## Determination 2019/037

# The refusal to issue a code compliance certificate for a 17-year-old house with a corrugated cellulose fibre cladding system at 7B Mayor View Terrace, Waihi Beach

**Figure 1: Approximate layout of the house**

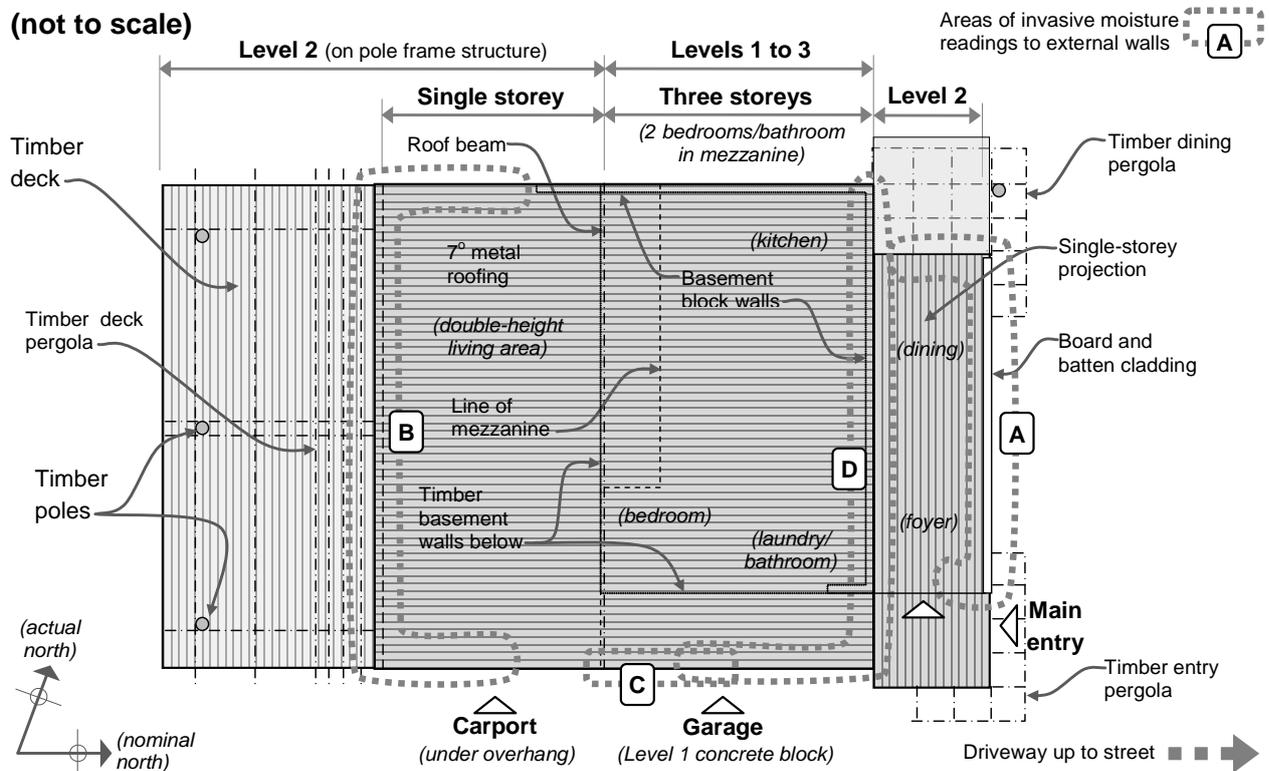
5.2.2 The building surveyor recorded the following invasive moisture readings from areas considered to be at risk of moisture penetration (refer Figure 1 for location of areas):

- Area A: Level 2 north single-storey lean-to (clad in board and batten):
  - 15% at north jamb to entry door
  - 14% and 15% beside the entry window
  - 13% to 15% beneath north window jambs
  - 15% at jambs to rear door.
- Area B: Level 2 south living area (with cellulose fibre cladding):
  - 12% and 13% at jambs to full height west window
  - 13% to 15% at jambs to north deck doors
  - 14% and 15% at jambs to full height east window.
- Area C: Level 2 east Bedroom 3 (with cellulose fibre cladding):
  - 12% to 16% beneath east window jambs.
- Area D: Level 3 north mezzanine (with cellulose fibre cladding):
  - 10% to 13% beneath east window jambs to Bedroom 1
  - 12% to 14% beneath north window jambs to Bedroom 1
  - 11% beneath north window jambs to Bedroom 2
  - 11% beneath north jamb to west window of Bedroom 2.

5.2.3 The building surveyor noted that all readings were ‘well within the acceptable margin. Readings over 18% generally indicate that moisture is entering the framing and further investigation is needed. I note that the building surveyor’s inspection was in late summer and readings are likely to represent the lower levels of expected seasonal variation, with higher readings expected during wetter months.
